**MINUTES OF 62<sup>ND</sup> MEETING OF EXPERT GROUP ON ZOO DESIGNING OF  
CENTRAL ZOO AUTHORITY**

**MONDAY, 13<sup>TH</sup> JULY, 2015**

## IV. Mini Zoo cum Deer & Tiger Safari, Bathinda, Punjab

### 1. Revised design of proposed construction of enclosure for Leopard:

# FRONT ELEVATION OF LEOPARD ENCLOSURE

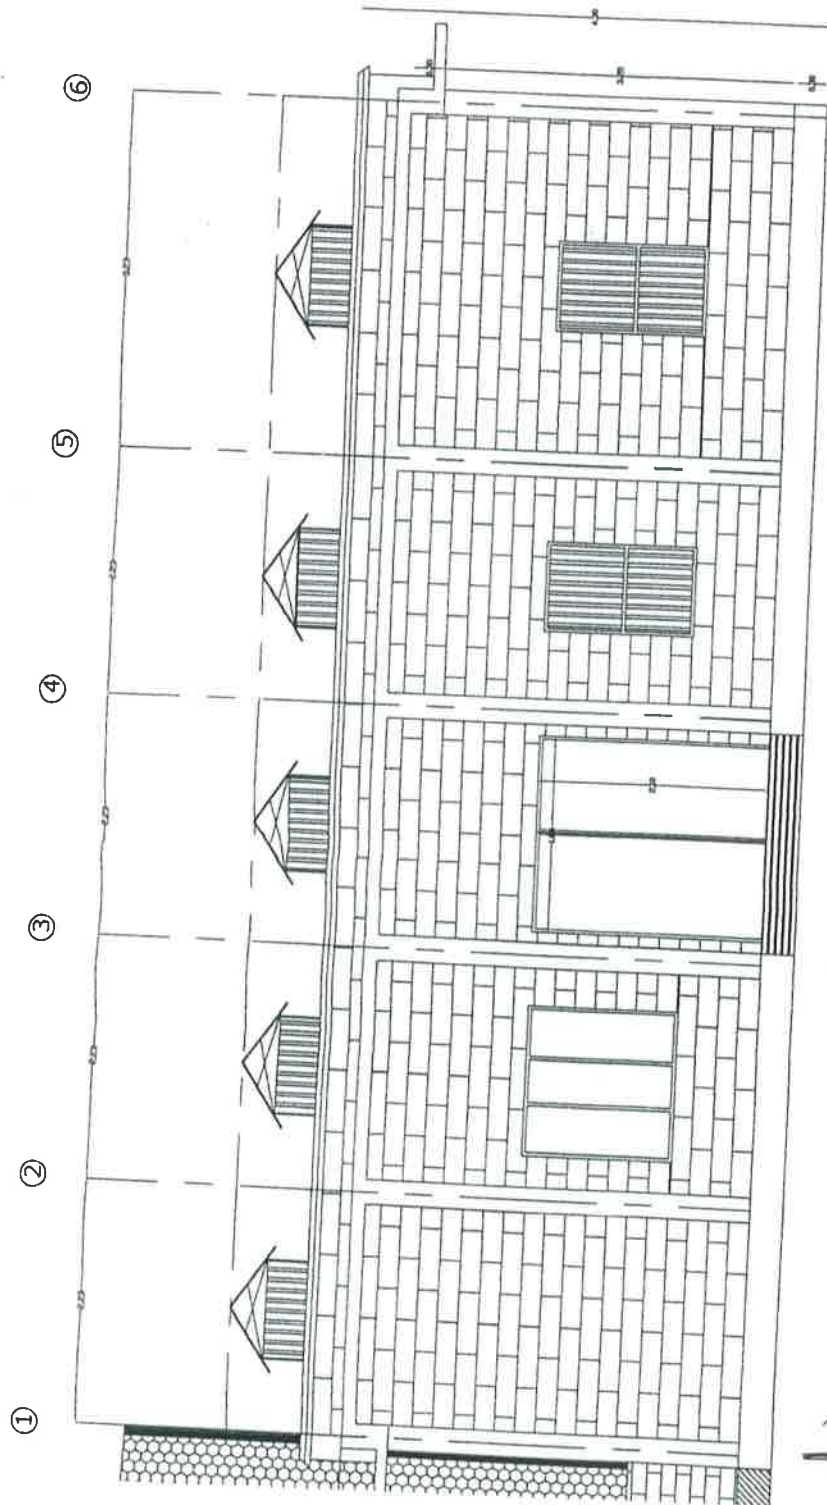
Members, on scrutiny of revised design of proposed construction of enclosure for Leopard at Mini Zoo cum Deer & Tiger Safari, Bathinda, Punjab, approved subject to compliance that dimensions of feeding cells shall not be less than 2 mts x 1.8 mts x 2.5 mts (length x breadth x height).
